ZRD2: Zoning Challenge
with response

Zoning Challenge and Appeal Form (for approved applications)

RE: Zoning Challenge 200 Amsterdam
Block 1158, Lot: 133, Job No:
122887224, Doc. 7

*Areas covered by the 1987 zoning lot classified by use of land (with 200 Amsterdam shown as constructed).
Gerrymandered zoning lot of 200 Amsterdam and 200 West End Avenue shown in red*

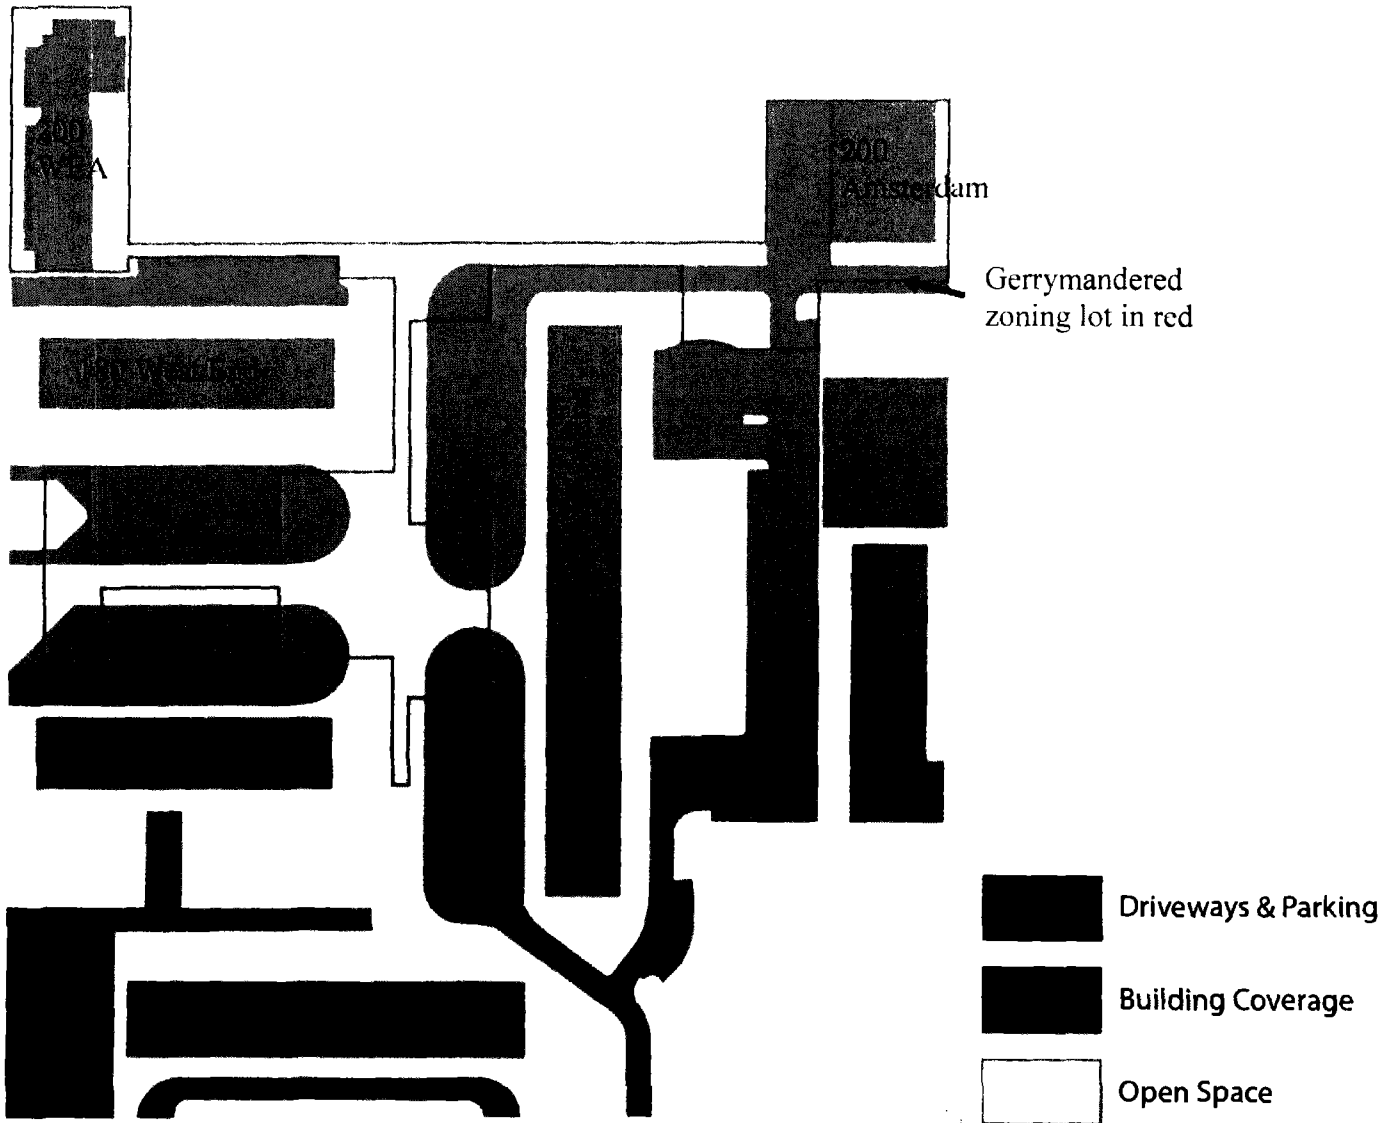
As stated in the Zoning Resolution, up to 50% of the required open space may be accessory parking, driveways, loading docks and bike parking. These uses are shown in gray above.

By my office's calculations, 33,983 SF of the open space on the gerrymandered lot is used for driveways and parking. According to 12-10, an Accessory use:

The parking and driveways are accessory to the uses on the Lincoln Towers zoning lot. They are not accessory to the uses on the gerrymandered lot since there is no parking provided for 200 Amsterdam or 200 West End Avenue. Uses accessory to another zoning lot are not permitted obstructions in Open Space, and thus, the 33,983 SF cannot be counted as open space in 200 Amsterdam's zoning calculations.

In response to the claim, the Department has issued a notice of objections and an intent to revoke to verify the open space ratio and that the zoning lot was properly formed.

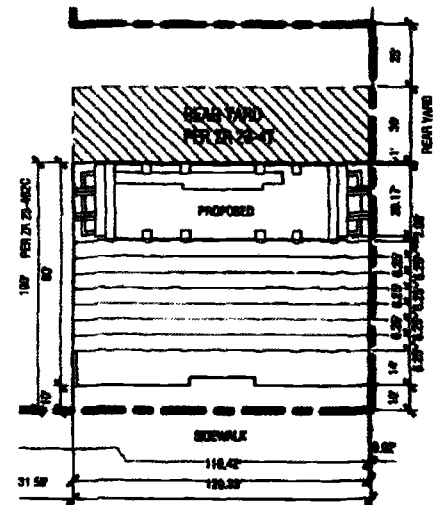
The proposed rear yard of 200 Amsterdam from the ZD1 is shown to the right. It is used as parking that is accessory to Lincoln Towers. As was stated earlier in this letter, an accessory use, "is a use conducted on the same zoning lot as the principal use to which it is related." Consequently, the proposed rear yard does not comply with 23-44.
